MEMORANDUM

RE: Beaumont Pointe Specific Plan Project – Response to Comment Letter

The Law Office of Abigail Smith on behalf of the Sierra Club dated February 20, 2024.

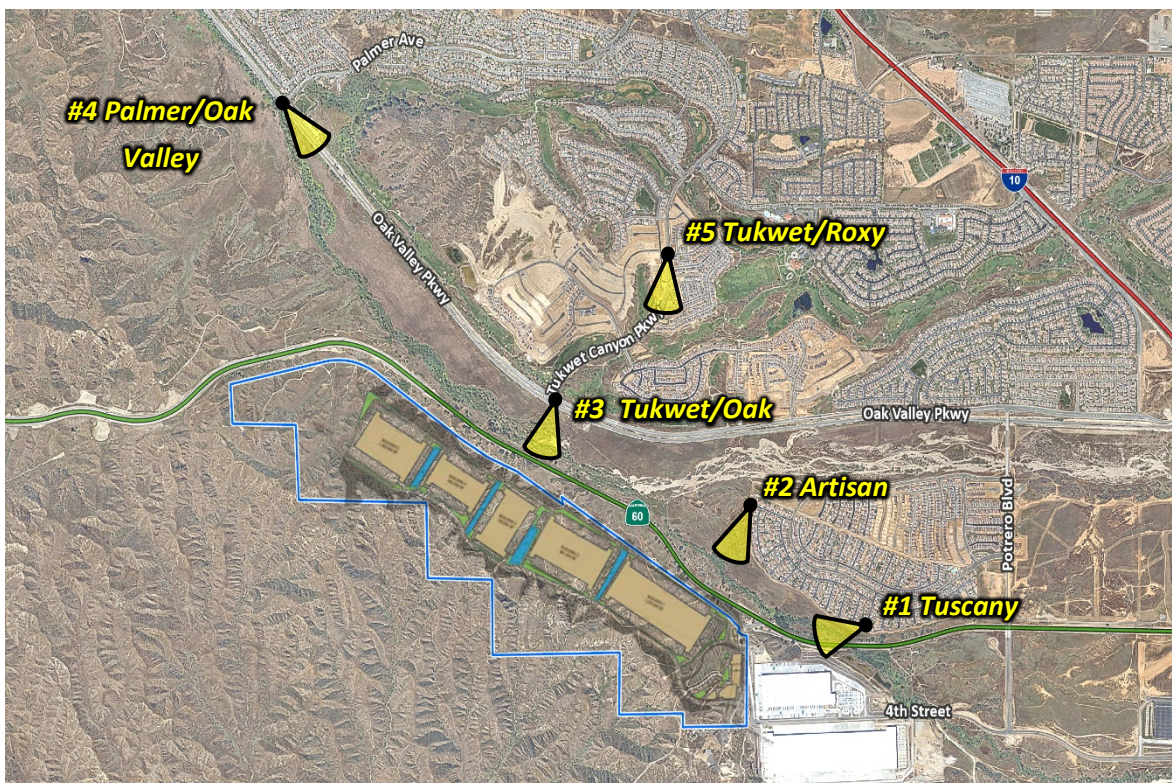
The record does not disclose the level of impact. There are no “before” photographs of the site with sufficient detail to show how the Project will impact it, and there are no visual simulations of the actual development, i.e., there are no visual depictions to show the buildings, lighting, and roadways including relative to surrounding vantage points such as from homes to the east of SR 60 or from SR 60. The record contains Figure 4.1-2, but this is not sufficient to provide realistic representations of Project buildings from surrounding vantage points (*see e.g.* Figure 4.3.-1). This single visual model does not illustrate what the buildings will actually look like and do not show the urban infrastructure including lighting (40-60 foot light poles) including at nighttime. Nor does it show the commercial buildings including 125-room hotel which presumably will be a prominent feature on the hillside given its planned location on the northeast corner of the site. Further, the EIR does not discuss whether the site contains rock outcroppings and whether these will be altered because of the Project. The permanent destruction of rock outcroppings must be disclosed and mitigated. The EIR indicates that some “blasting” may occur of landforms.

View simulations were presented at the Planning Commission Hearing on January 10, 2024, and are shown below. The images below show views that were photographed on a location map; existing views; and proposed view simulations that reflect the design grading plan, the conceptual building architecture and colors, and the Landscape Screen Plan with five-years and 10 years of plant growth after initial planting. The view simulations reinforce the analysis of aesthetic impacts in DEIR and the conclusion that there will be no significant visual impact with respect to preservation of scenic views within the area or scenic vistas.

EXHIBIT 4-4: PROJECT (TRUCK) TRIP DISTRIBUTION WITH POTRERO BOULEVARD INTERCHANGE

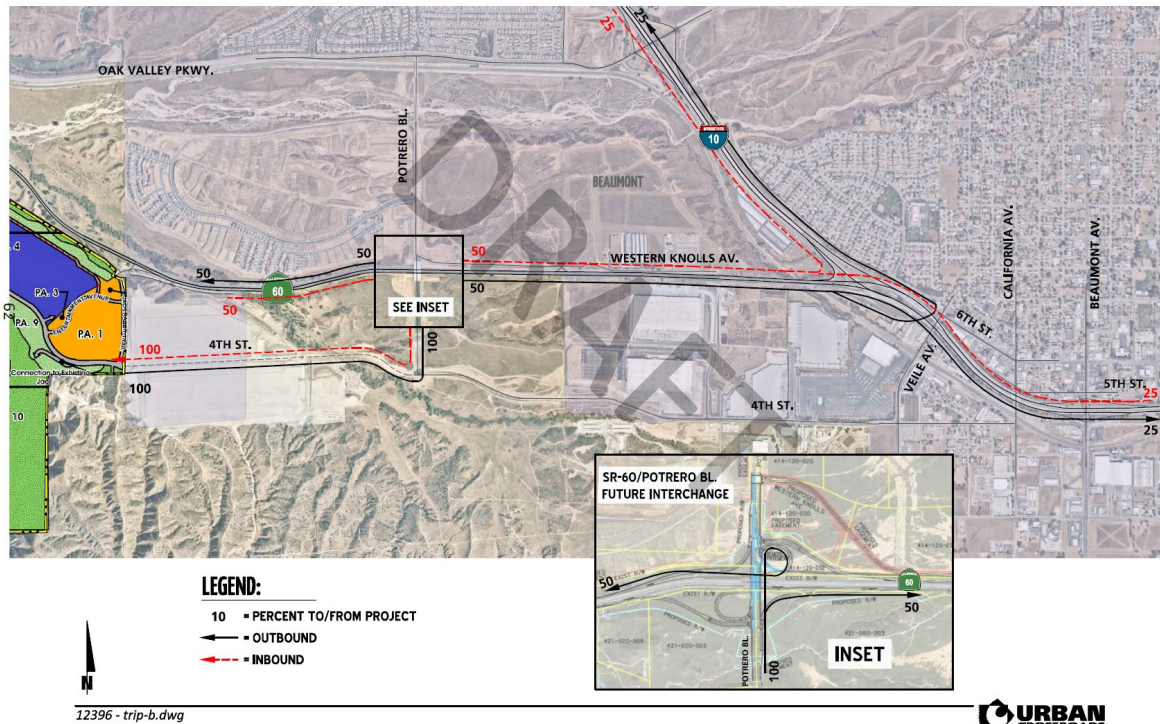
- 17 The commenter states that the Project must establish truck routes or Mitigation Measure MM 4.3-17 is ineffective. As discussed in the Supplemental CEQA Memorandum, Mitigation Measure MM 4.17-2 (below) has been incorporated into the Project which adds additional enforcement mechanisms to ensure trucks follow the Project's planned truck routes.

2. Project Build-Out of the Project (Ultimate) - Truck route **after** construction of the Phase 2 Potrero Interchange improvements will be developed. Similar to the interim phase, the ultimate truck route shall be developed with input from City staff to ensure sensitive land use receptors are considered, and consistent with Planning Commission/City Council direction. The ultimate truck route will be consistent with the **Project truck trip Distribution With Potrero Boulevard Interchange Improvements** per Exhibit 4-4 of the approved TIA shown below. This ultimate truck route may also be used during construction of the Project depending on the Project development schedule and the Phase 2 Potrero Interchange improvement schedule.

- Truck route maps shall be provided to all truck drivers.
- Truck route signage shall be provided at each exit point/gate for loading areas.
- Identify and provide recommendations for physical improvements (if any) to be implemented as part of the TTDMP program. Improvements to deter truck traffic may be implemented on routes where trucks should avoid, minimizing impacts of truck traffic to sensitive receptors. Additionally, improvements on preferred truck routes may be implemented to promote truck traffic on the City identified and preferred routes. The City Planning/Building Department may verify completion of physical TTDMP improvements as part of the Certificate of Occupancy process.
